Borumba Pumped Hydro Energy Storage Project – Exploratory Works Preliminary Documentation

Response to Public Comments

DOCUMENT NUMBER: BR-NA-NON-EMG-RPT-00027

Figure 1: Phases required for Borumba PHES Project definition

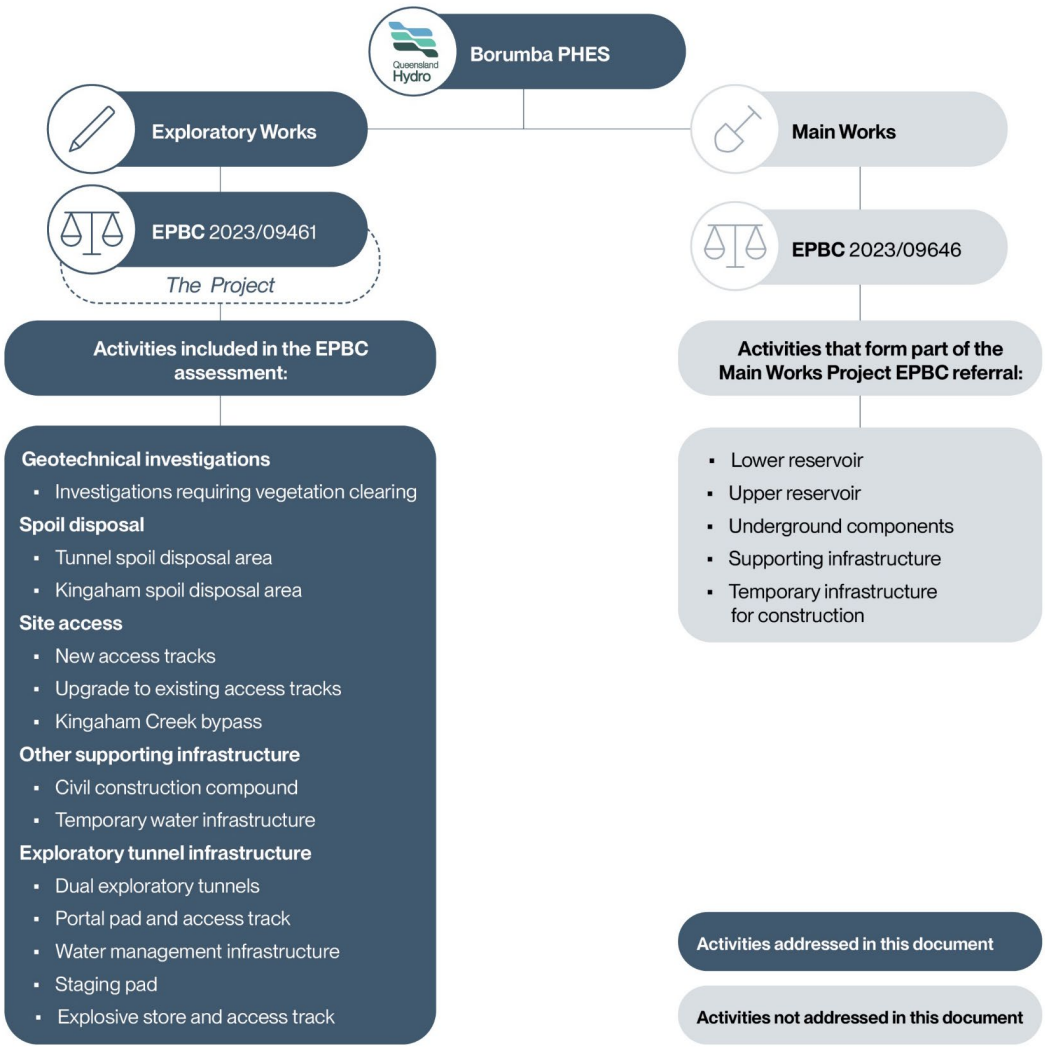
- *"I disagree with Figure 4 (Borumba PHES Project definition) where it shows that the Borumba PHES Project includes two Project phases, the Exploratory and the Main Works. There is a third phase and that is the Transmission lines from Borumba Dam to Halys and Borumba Dam to Woolooga. Transmission lines are essential to this project and will have facilitated/cumulative impacts on Matters of National Significance."*

While the Exploratory Works are part of the broader Borumba PHES Project and will inform the Main Works, they are a separate controlled action to the Main Works under the EPBC Act (refer to the response in Section 3.1).

Figure 10: Geotechnical investigation sites at Area 1

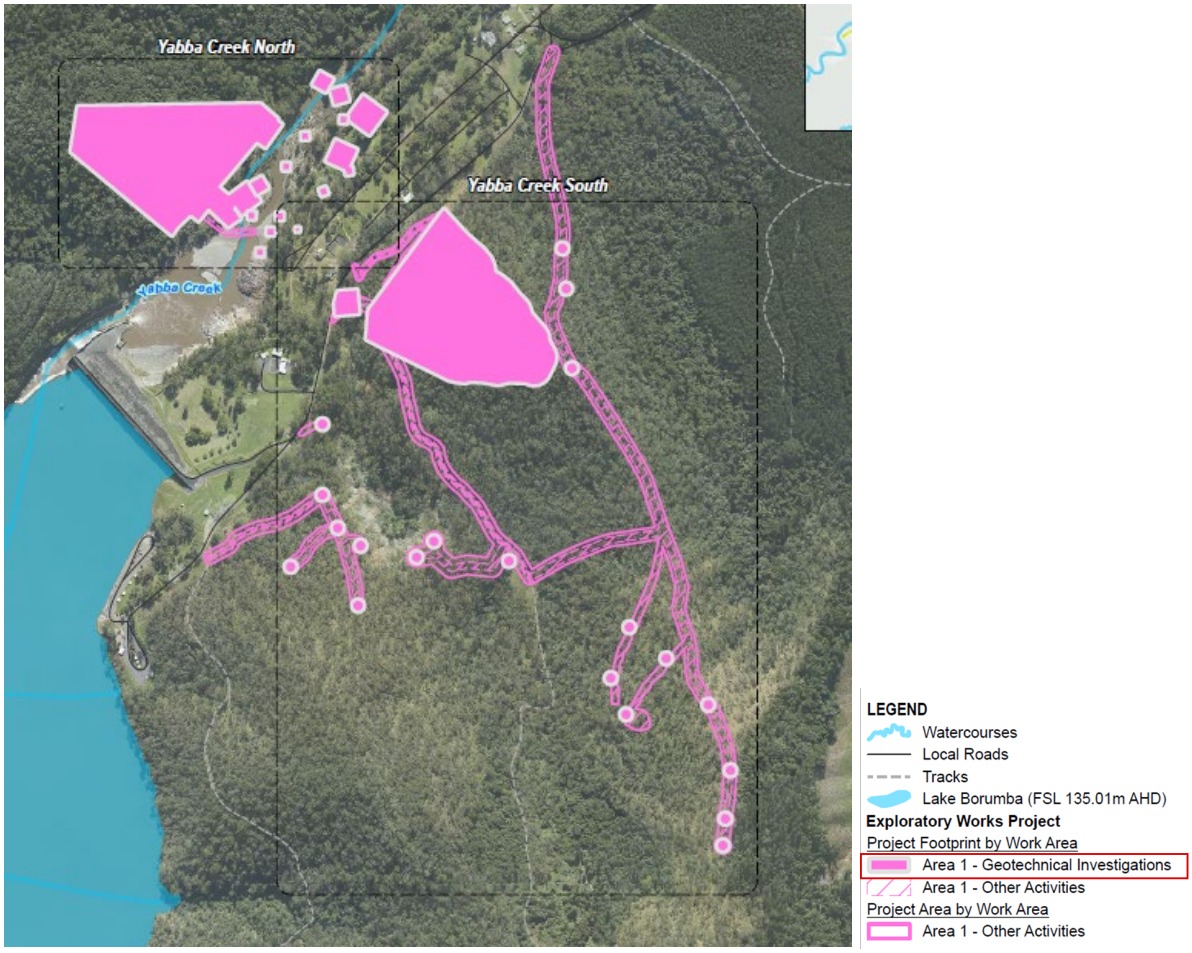
Some of the tracks shown on Figure 10 and Figure 11a-11c in the published Preliminary Documentation did not appear to lead to geotechnical investigation areas. This has been amended in the revised Preliminary Documentation. However, it is noted that geotechnical investigations may occur along the access tracks, but the disturbance will be contained within the track footprint, with no additional disturbance area required.

FIGURE 10a

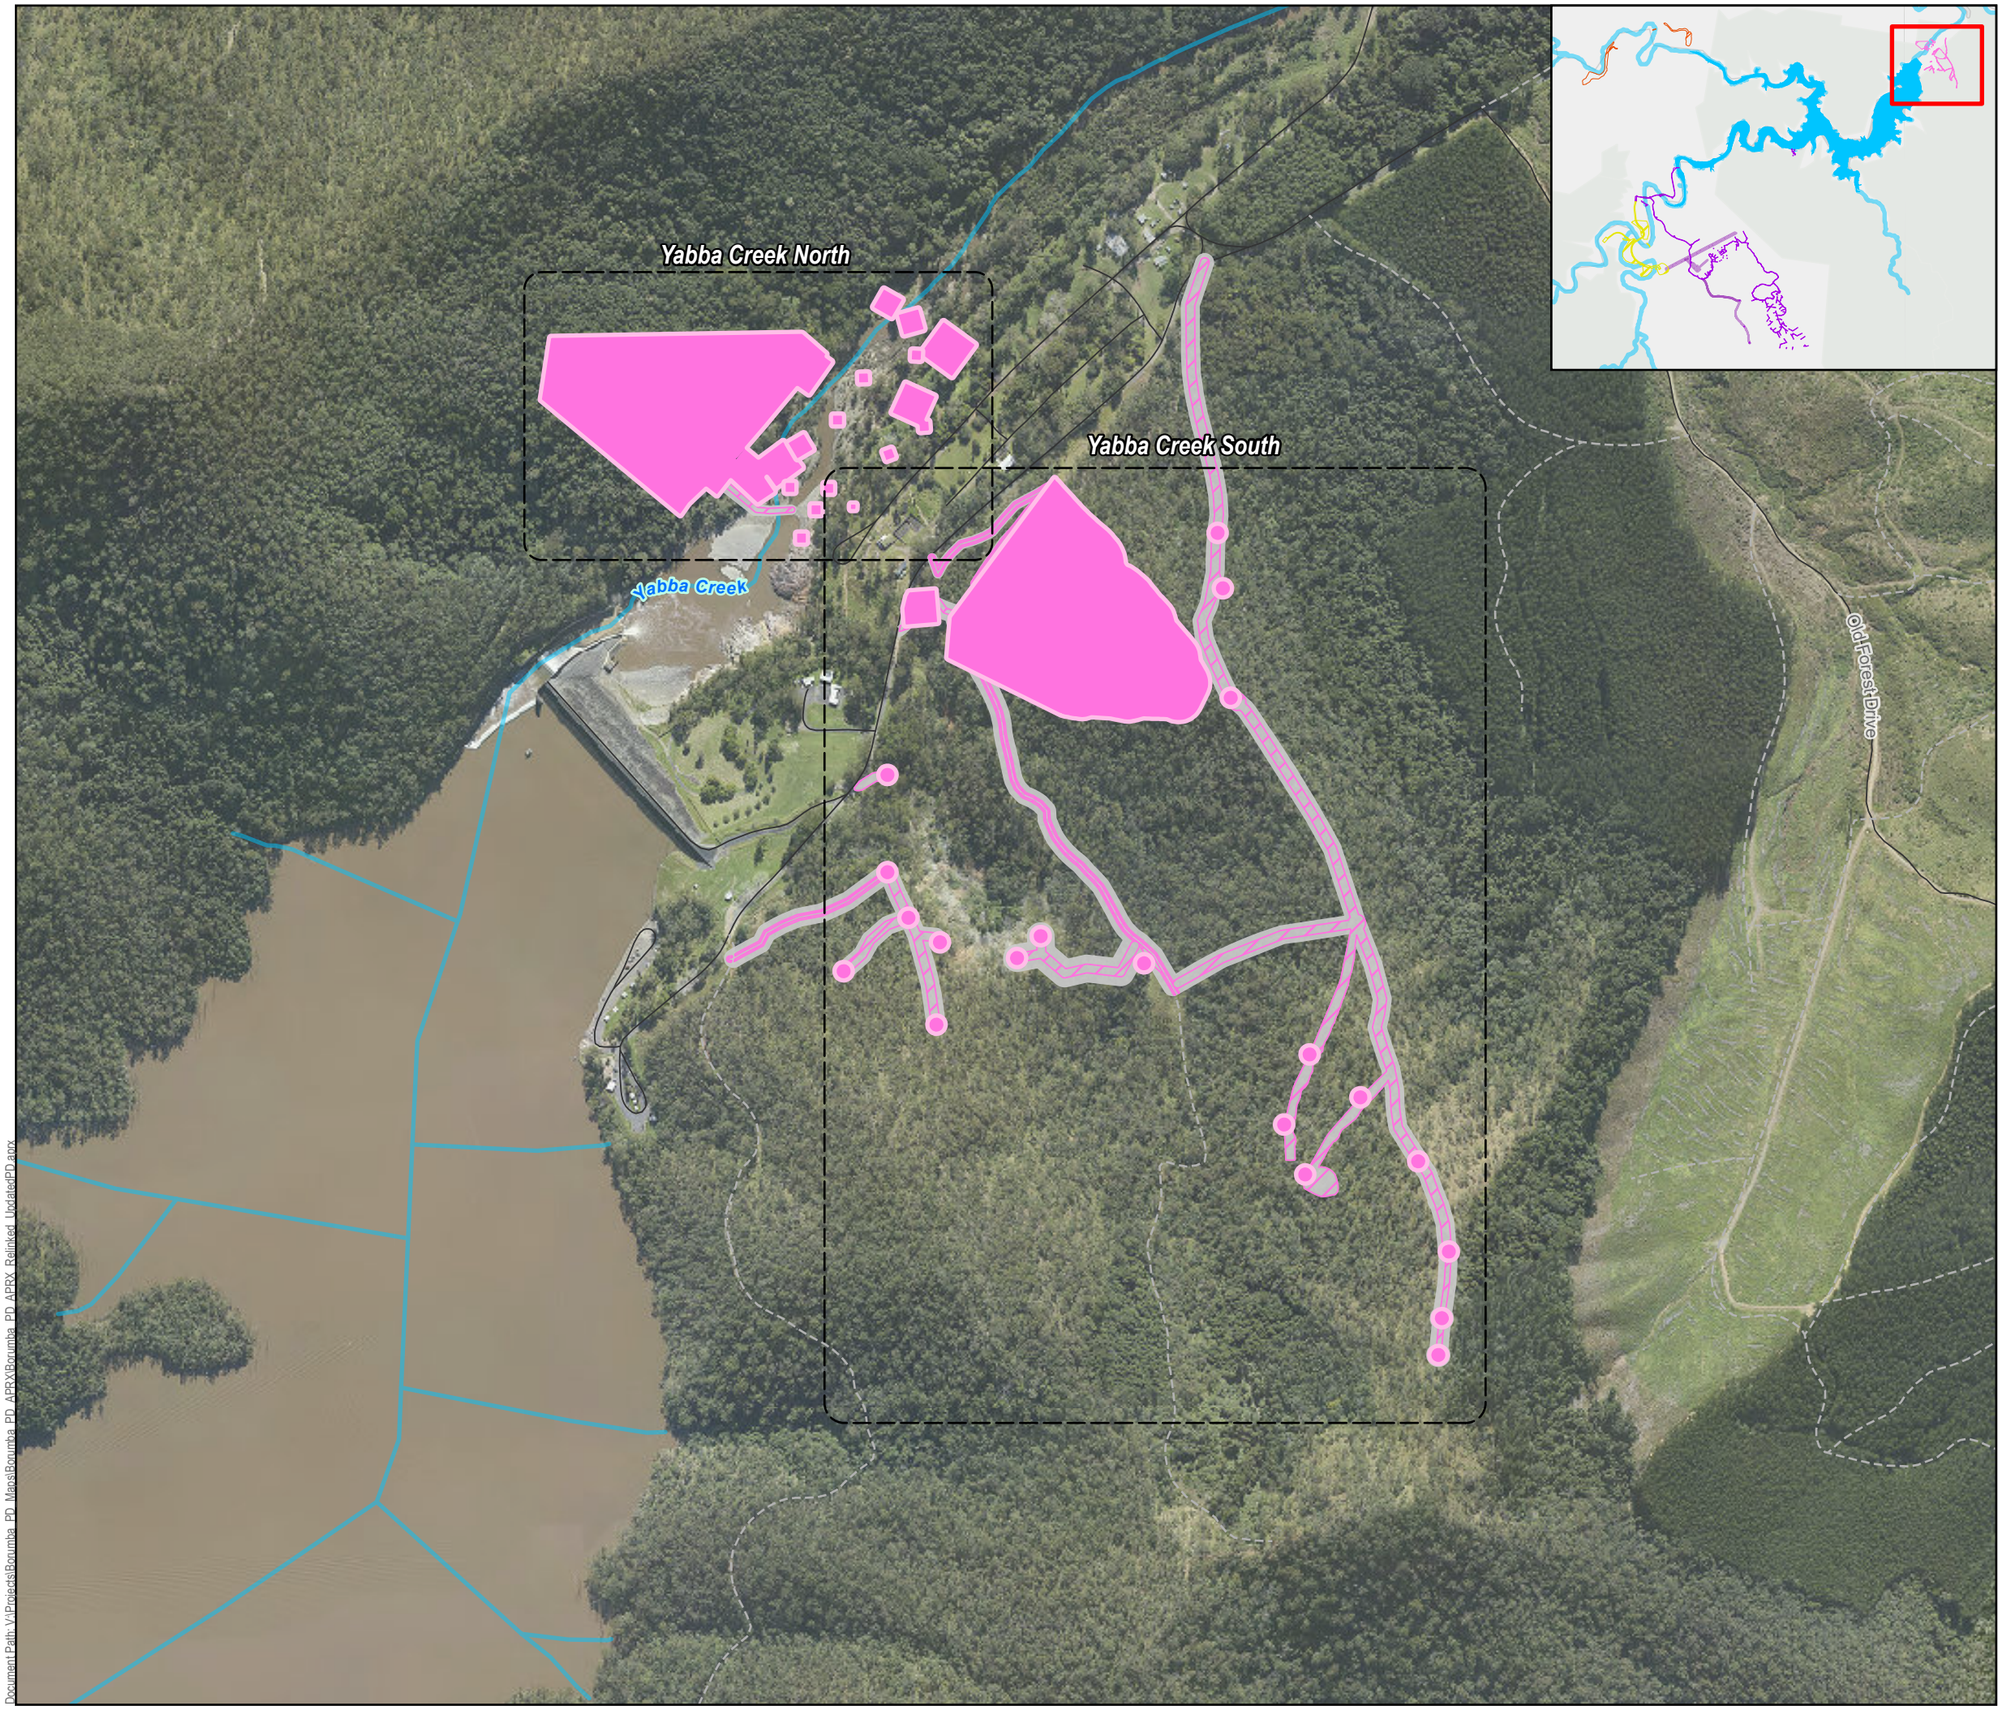
113	Figure 10a: Needs explanation of why some of the track upgrades are needed when they do not appear to access a drill hole. Using the word "anticipated" in the title gives the impression that the location is not clearly defined and likely to change in the future. Suggest removing "Anticipated". In area 1 (Borumba dam wall) replace solid pink colour with cross hatching so the vegetation can be seen like all the other maps.Also a contour overlay needs to be put on the figure to allow the reader to assess erosion risks and drainage lines. Explain the small squares on the map in the legend and the text. Why does area 1 not have the drilling dots showing where the drilling is proposed to take place.	3.5, 3.5, 3.6
113	Figure 10b Using the word "anticipated" in the title gives the impression that the location is not clearly defined and likely to change in the future. Suggest removing "Anticipated". Map area does not include all the proposed Kingaham Creek access road works to the west of the figure. Suggest using slightly higher scale so it covers all the proposed site disturbance in that area. Also a contour overlay needs to be put on the figure to allow the reader to assess erosion risks and drainage lines. Legend colour appears incorrect.	3.5, 3.5, 3.6
